**Re: GE-Pittsfield/Housatonic River Site
Plant Site 3 Groundwater Management Area (GECD340)
Addendum to Baseline Monitoring Program Proposal**

GENERAL ELECTRIC COMPANY
PITTSFIELD, MASSACHUSETTS
GMA 4 BASELINE MONITORING PROGRAM

**REVISED BASELINE
MONITORING PROGRAM**

FIGURE
1

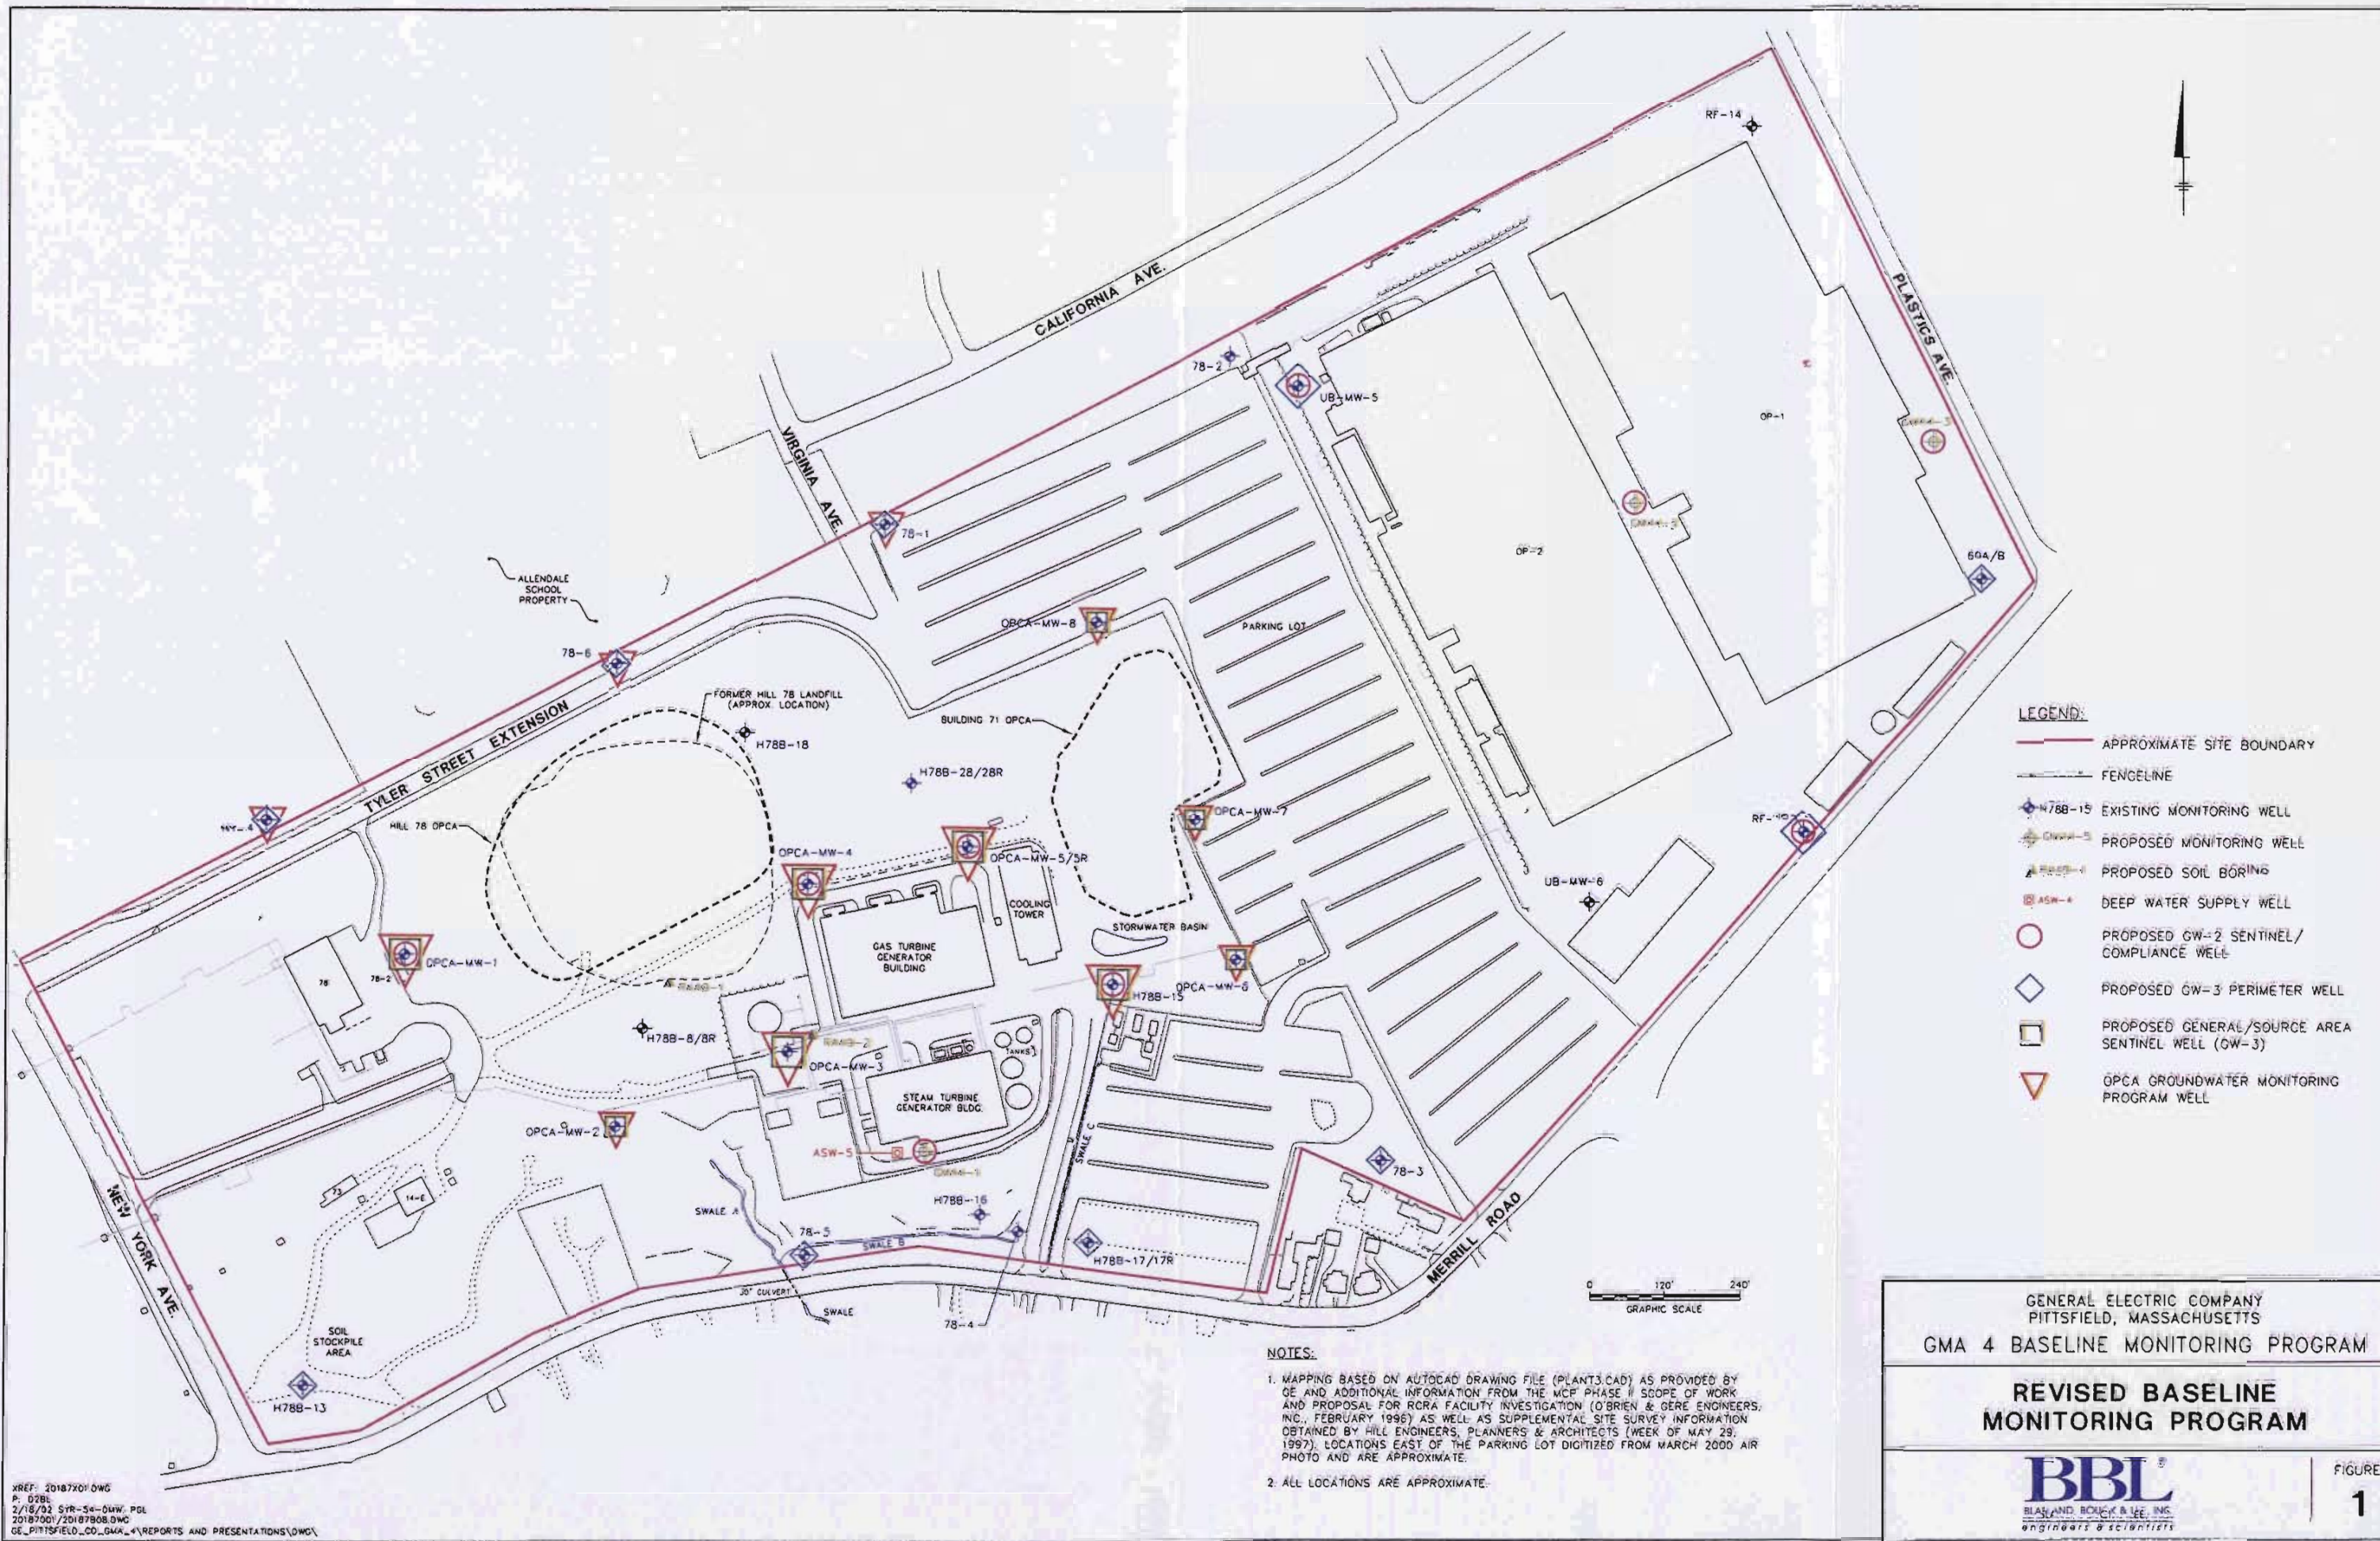
Figure 1 illustrates the GMA 4 baseline groundwater monitoring program well locations.

- Well GMA4-2 was installed as a GW-2 sentinel well between Buildings OP-1 and OP-2.
- A new GW-2 sentinel well/GW-3 perimeter well (GMA4-3) will be installed along Plastics Avenue near Building OP-1. This well will replace well RF-14 for groundwater quality monitoring purposes. However, well RF-14 will continue to be monitored for groundwater elevation on a quarterly basis.
- Well UB-MW-5 will be added as a GW-2 sentinel well, and will also be monitored as an upgradient GW-3 perimeter well instead of well 78-2. Well 78-2 will be monitored for groundwater elevation and NAPL presence only.

- Well H78B-13 will be monitored as a GW-3 perimeter well instead of well NY-2, as previously proposed. Although GE had previously thought that well H78B-13 was destroyed during the recent expansion of Merrill Road, it was located during the January 2002 well inventory. However, the well was found to contain significant sedimentation, which GE will attempt to remove. If the sediment removal attempt fails, GE will replace the well.

Further, GE proposes to replace well H78B-17 with well H78B-17R as a GW-3 perimeter well in the baseline groundwater sampling program. Well H78B-17R is a 4-inch-diameter well and thus should produce more water for sampling than well H78B-17, which is a 1-inch-diameter well. Well H78B-17 will be retained for water level measurements, as a paired well with well H78B-17R to assess vertical gradients.
